# UNITED STATES PATENT AND TRADEMARK OFFICE

APPLICATION NO.	FILING DATE	FIRST NAMED INVENTOR	ATTORNEY DOCKET NO.	CONFIRMATION NO.
10/580,006	05/19/2006	Lars Kristensen	IPB.026	7629

### Office Action Summary

## **DETAILED ACTION**

Fig. 1: Leue et al. (US 3,248,832)

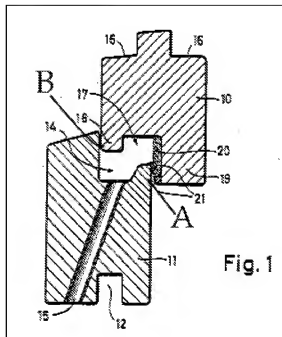
With regards to claim 10 and 19: Leue et al. discloses window frame (11) comprising a window having an inner surface and a sash frame (10), wherein each of the window frame (11) and sash frame (10) include a top and bottom frame member (transverse parts) and lateral frame members (longitudinal parts) (col. 1, lines 33- 39). Leue et al. further discloses a first groove (14) capable of drainage formed in the window frame (11), and a second groove (16) capable of drainage formed in the sash frame (10), wherein the window frame (11) has an inner surface adjacent to the sash frame (10) has an outer surface adjacent to the window frame (11), wherein the first

groove (14) has concave surface extending along the inner surface of the window frame (11) and includes a flange (A) protruding from the inner surface of the window frame (11), and wherein the second groove (16) has a concave surface extending along the outer surface of the sash frame (10), and include a flange (B) protruding from the outer surface of the sash frame (10). Note, the grooves Leue et al. are considered concave as they form hollowed out portions, the drainage grooves of applicant's are considered no more concave than that of Leue et al. The grooves of Leue et al. would be expected to perform equally well to that of applicants. Note the window of Leue et al. is capable of being installed on a roof.

Leue et al. further discloses the window having a covering in the form of a elastic packing strip packing strip composed of foam rubber with plastic cover extending from the window frame (col. 1, line 39-46), but fails to disclose the window comprising a flashing member.

However, Ripley discloses it is known in the art to applying flashing (25) to a window structure (col. 3, lines 2-13).

It would have been obvious to one of ordinary skill in the art at the time of the invention was made to modify the window of Leue et al. to include flashing as taught by Ripley in order to provide window structure with increased resistance to water intrusion.

With regards to claim 13 and 20: Leue et al. further disclose the first groove (14) formed in the inner surface of the window frame (11) constitutes a complex channel for the window frame (11), while the second groove (16) for in the outer surface of the sash frame (10) constitutes a complex channel for the sash frame (10). Leue et al. further discloses the cross section of the window frame (11) and sash frame (10) are the same throughout the transverse (bottom and top) and longitudinal (lateral) parts of the respective frames (col. 1, lines 33-39).
